**Origination Form**  
Proposed Revisions to a Standard Plans Index

<b>Originator:</b>	Turley, Joshua	<b>Index Number:</b>	102-201
<b>Date:</b>	6/17/2025	<b>Sheet Number(s):</b>	1-5
<b>E-mail:</b>	Joshua.Turley@dot.state.fl.us	<b>Index Title:</b>	Temporary Acrow 700XS Series Detour Bridge General Notes and Details

LAST REVISION 11/01/20 11/01/25	REVISION	DESCRIPTION:		FY <del>2025-26</del> STANDARD PLANS	TEMPORARY ACROW 700XS SERIES DETOUR BRIDGE GENERAL NOTE AND DETAILS	INDEX 102-201	SHEET 1 of 5
---------------------------------------	----------	--------------	--	---	--	------------------	-----------------

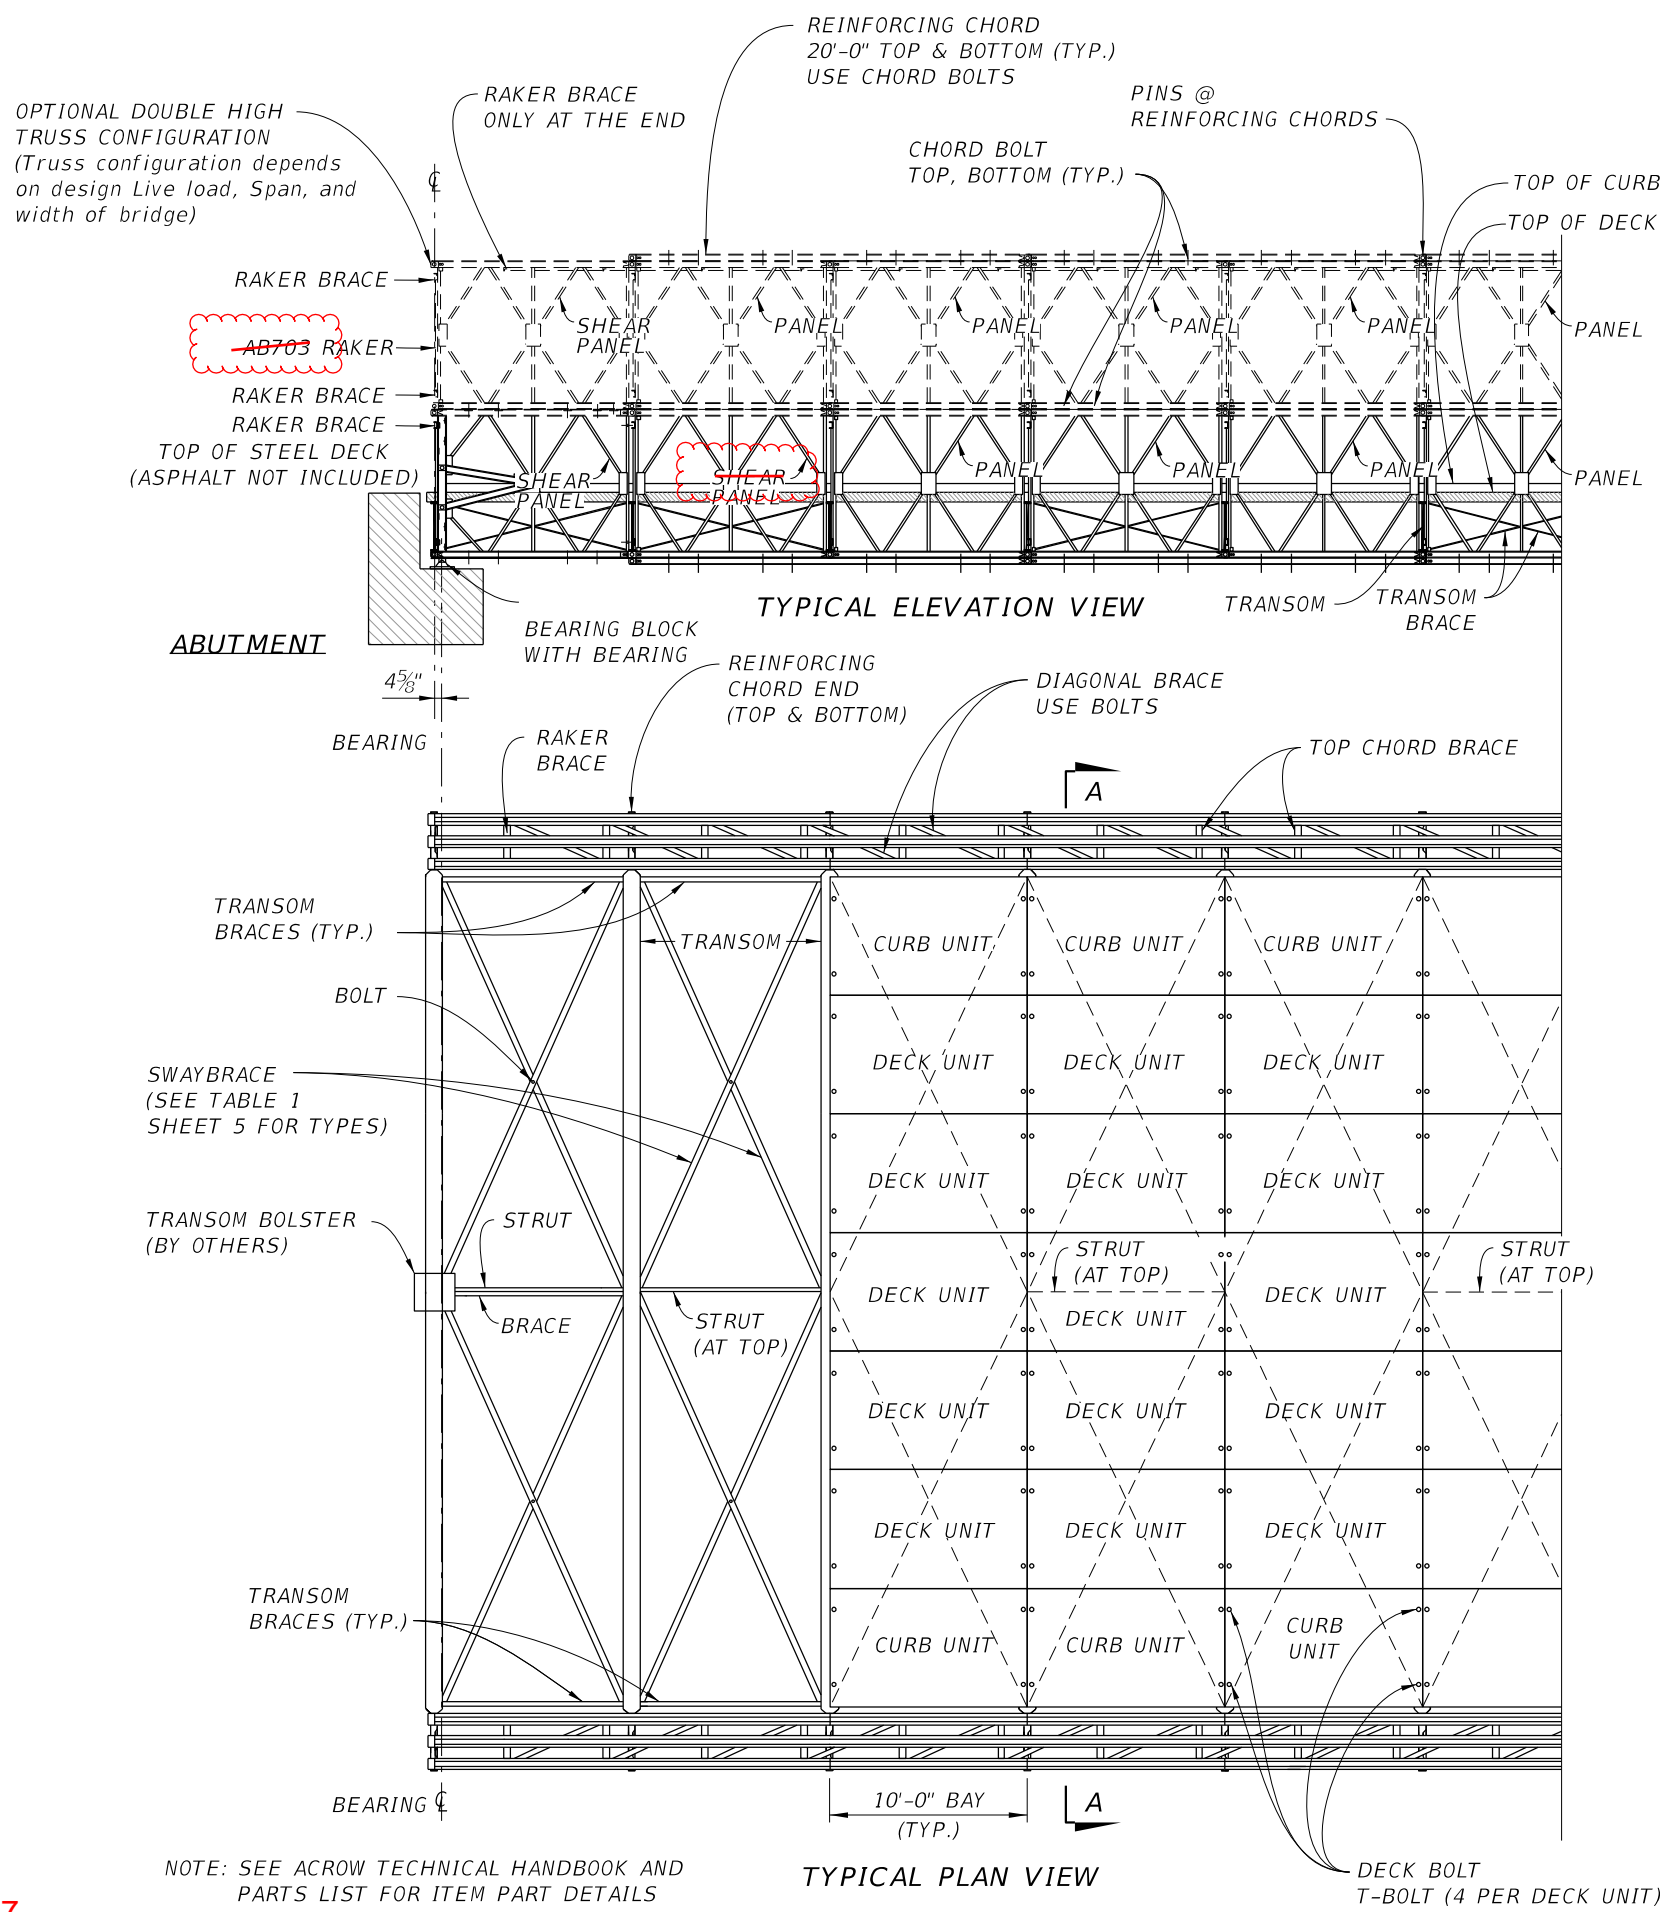
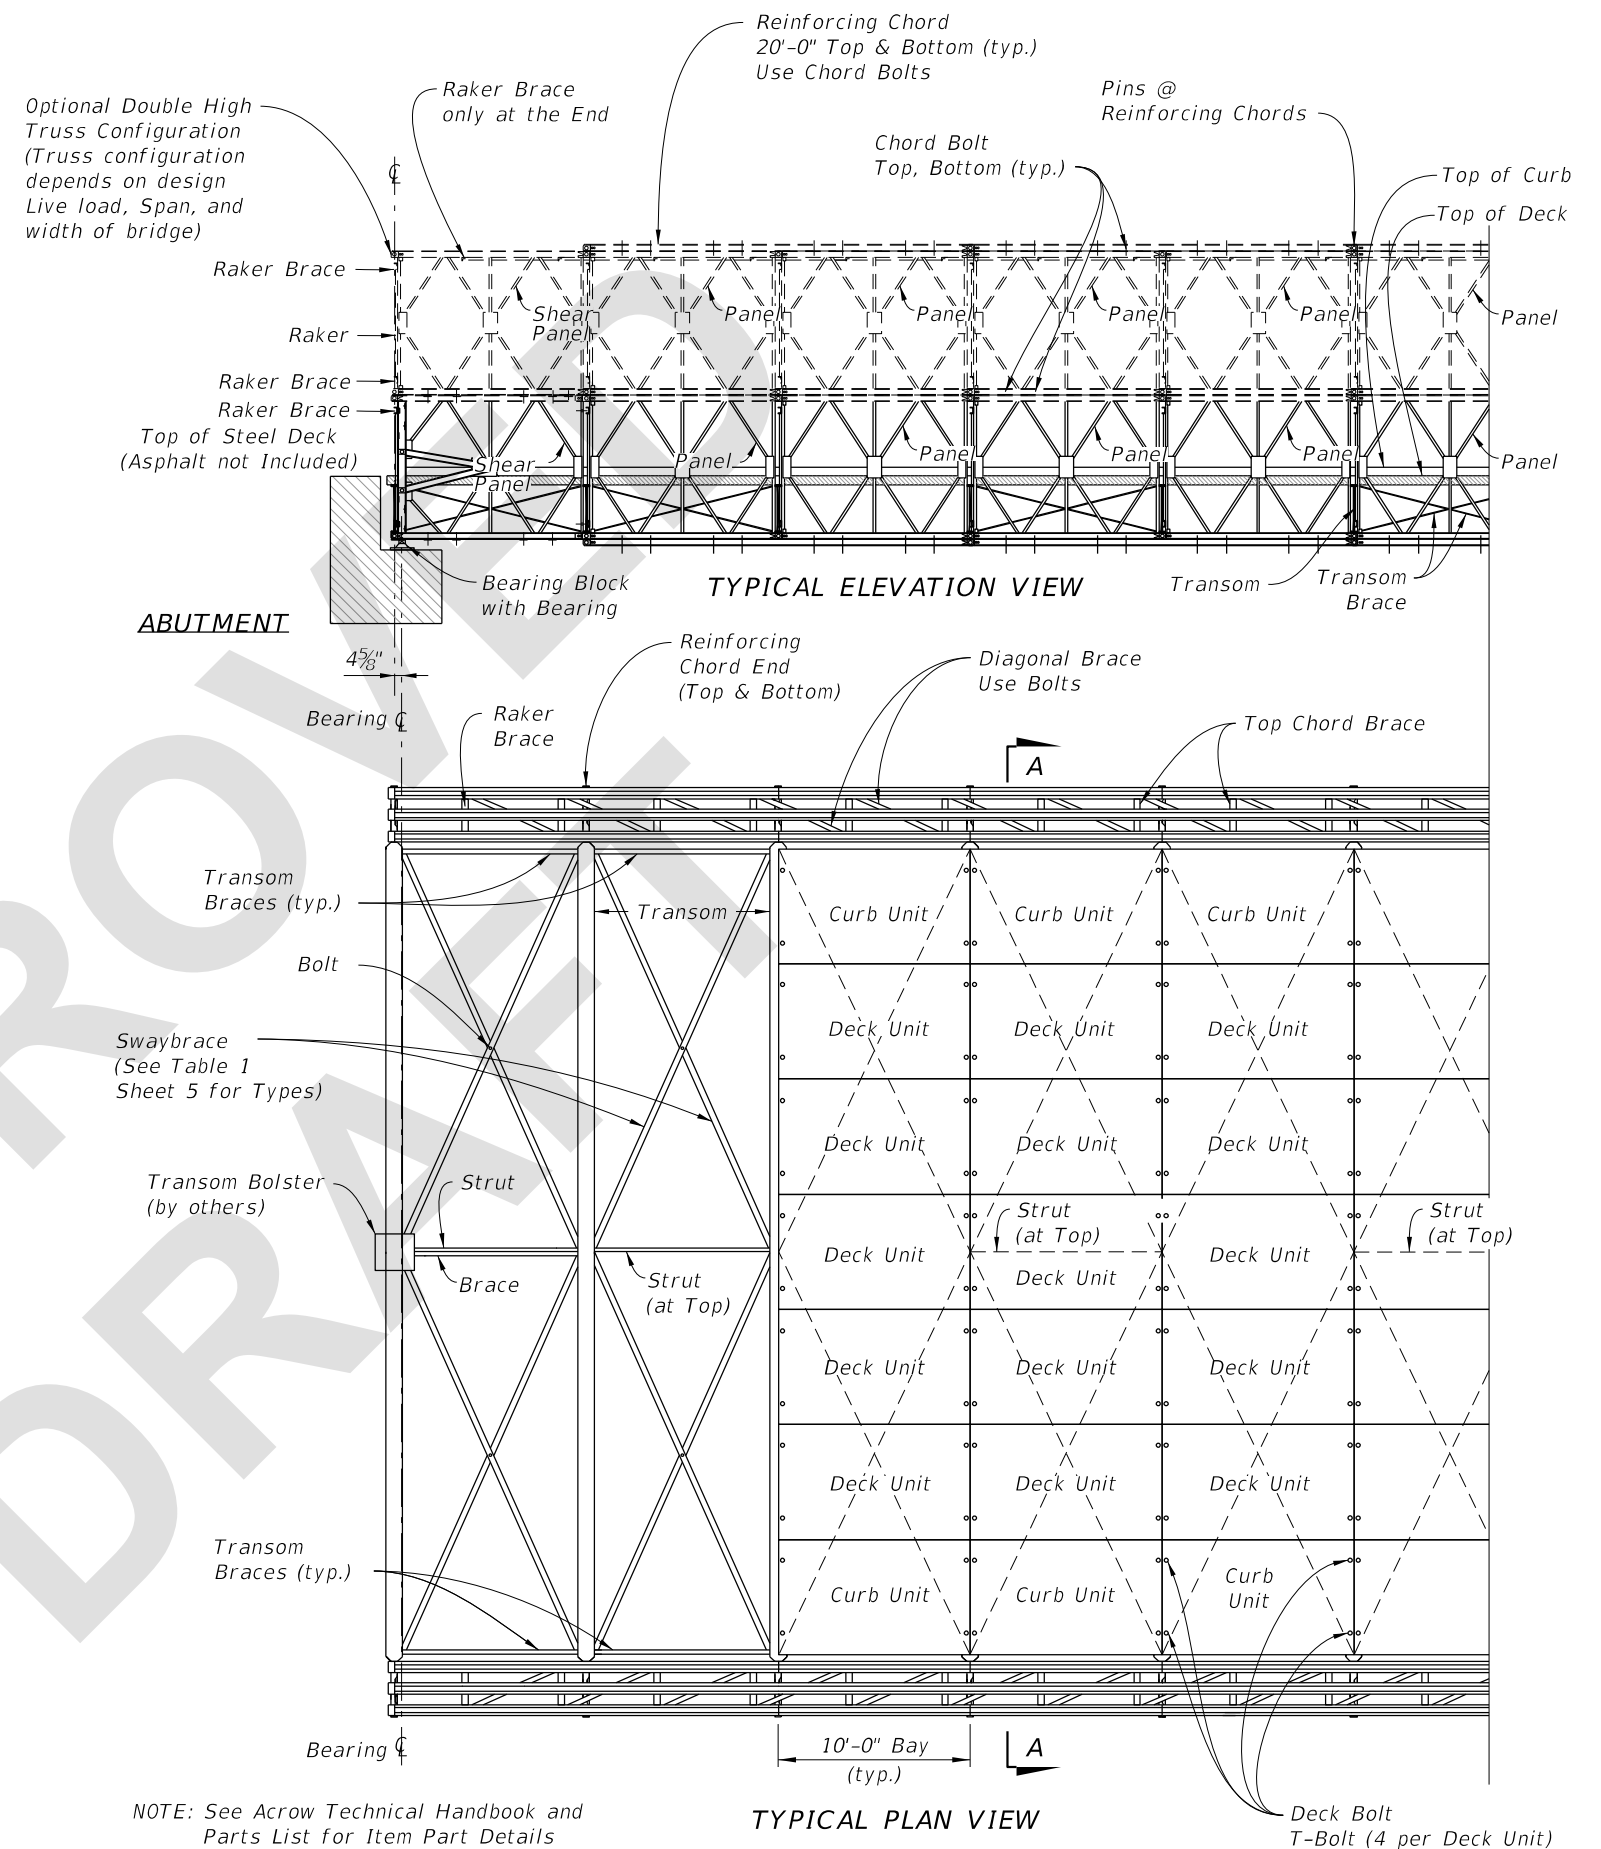
Sheet 1: Added some clarifying terms to the Notes. Removed errant shear panel and part number from TYPICAL ELEVATION VIEW.

except when deck and curb panels with an epoxy aggregate non-skid driving surface are used,

keeper channels

ends of the keeper channels

This Index is only applicable to the current FDOT inventory of temporary bridge components which are manufactured in accordance with Acrow Series 700XS three Lane 24',36', and 42' widths. Asphalt Overlay is required on the Bridge deck except when deck and curb panels with an epoxy aggregate non-skid driving surface are used, see Sheet 2 for details.

Distribution beam keeper channels restraining the distribution beams may be lengthened or shortened to center the distributing beam bearing on the cap beam. The ends of the keeper channels are to bear on the distributing beam end frame.

TYPICAL DETAIL AT INTERMEDIATE PIER (FOR CONTINUOUS SPAN DESIGN)

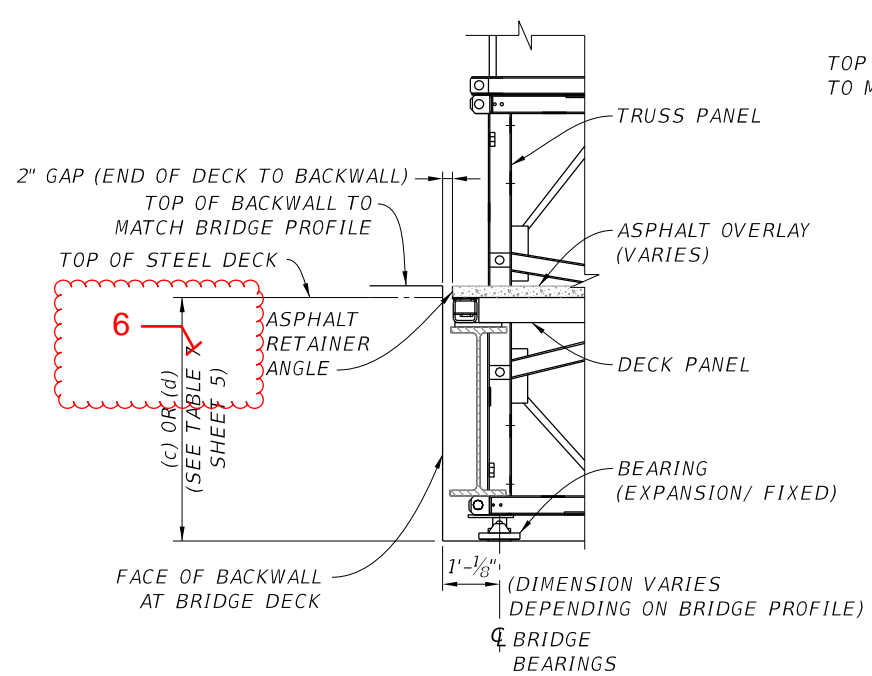
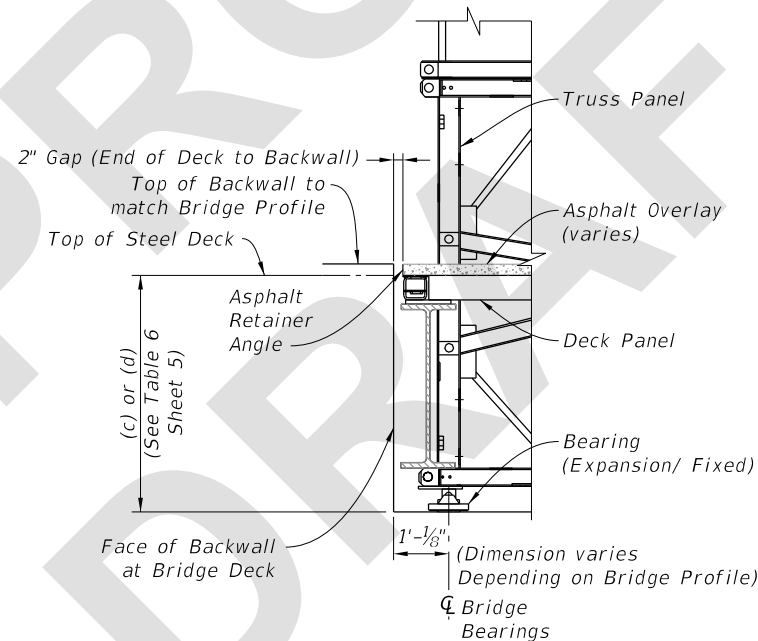
Sheet 3: Added clarifying notes to TYPICAL DETAIL AT INTERMEDIATE PIER. Corrected table reference in TYPICAL DETAIL AT ABUTMENTS. Added note to EOB AT DECK DETAIL

TYPICAL DETAIL AT INTERMEDIATE PIER  
(FOR CONTINUOUS SPAN DESIGN)
